CERTIFICATE OF APPROPRIATENESS

Property: 1810 Kane Street, Lot 6, Block 443, Baker W R SSBB Subdivision. The property includes a 2,050 SF, one-story, wood frame, single-family residence situated on a 5,000 square foot (50' x 100') interior lot.

Proposal: Alteration

- Remove and replace 9 original windows with 9 replacement windows custom made to fit in the same window openings. One of the windows to be replaced is rear facing and not visible from the right of way (ROW).

Figure 5 - Applicant Supplied Photo with New Windows on Porch

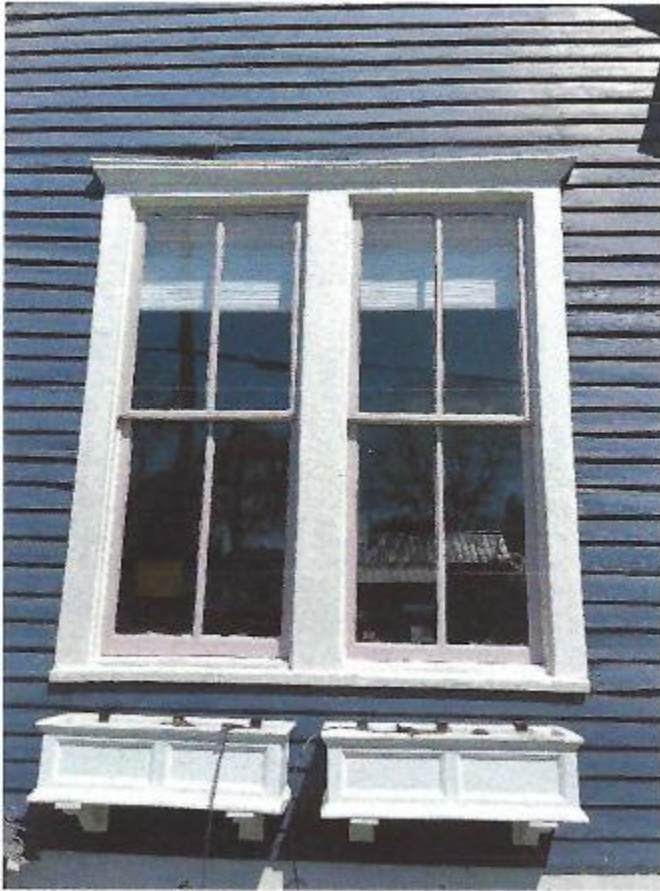
Recommendation: Denial of COA and issuance of a COR to re-install the 2 original windows that were replaced with new ones on the front porch and approval to replace the 1 rear facing, non-visible from the ROW, window.

Attached for review are pictures of the front of 1810 Kane showing two of the existing windows as well as the two new windows that were installed on the front porch. As you can see from the pictures, there is no apparent difference between the old and new windows. The new windows are as architecturally correct as possible, and as you can see are both recessed and inset as the existing windows.

Figure 8 - Diagram of Windows to be Replaced

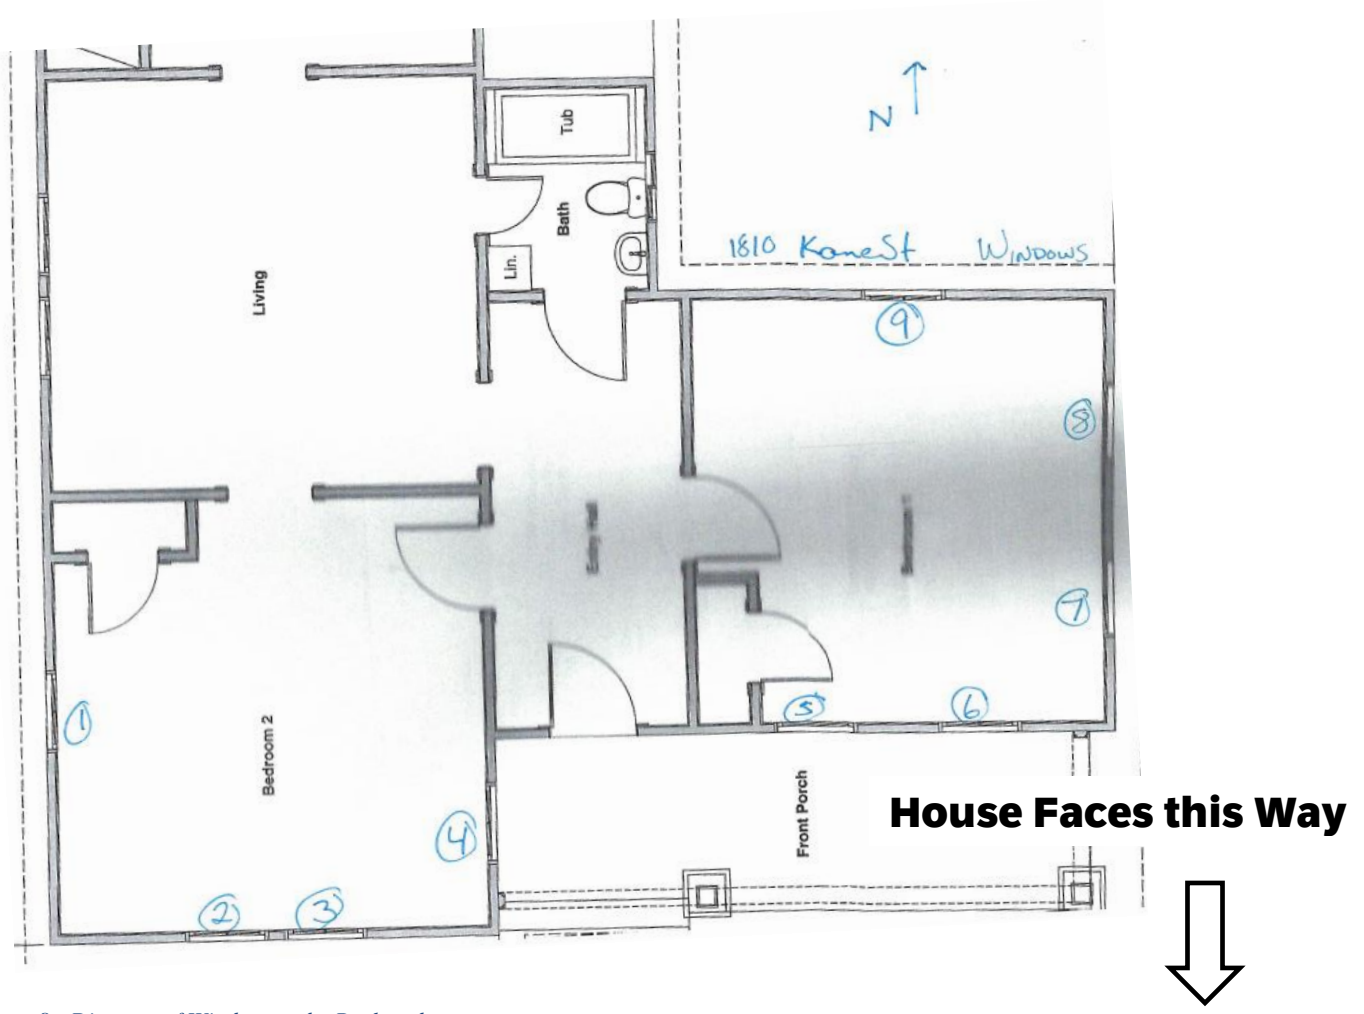
Approximately 7 months ago we ordered and paid for nine, custom, 2 over 2 architecturally correct, Jeld Wen wood frame windows to replace the existing windows. The cost for the 9 windows is approximately \$15,000 (nonrefundable) and installation will cost another \$12,000 or so. The intent is to reuse as much of the existing trim as reasonably possible. One window is on the west side of the house, five windows are along the front (south side) of the house, one window is on the east side of the house and one window is on north side opening on the back courtyard. Drawing and window plan is attached.

Figure 9 - Spec Sheet for Replacement Windows Proposed

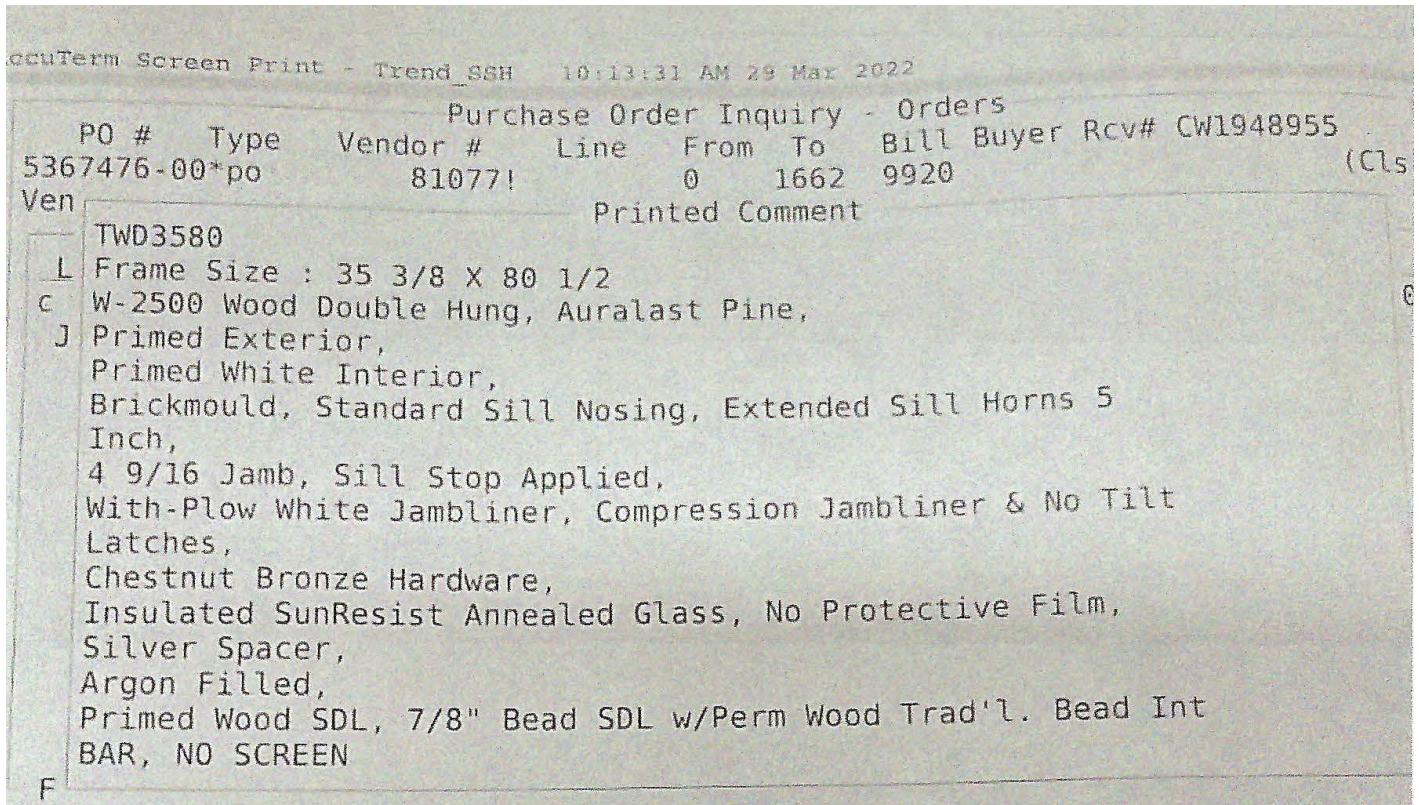
(6) New materials to be used for any exterior feature excluding what is visible from public alleys must be visually compatible with, but not necessarily the same as, the materials being replaced in form, design, texture, dimension, and scale. The proposed windows from the applicant appear to be high quality wood replacement type windows, such that if the existing windows were non-repairable, would be very acceptable.
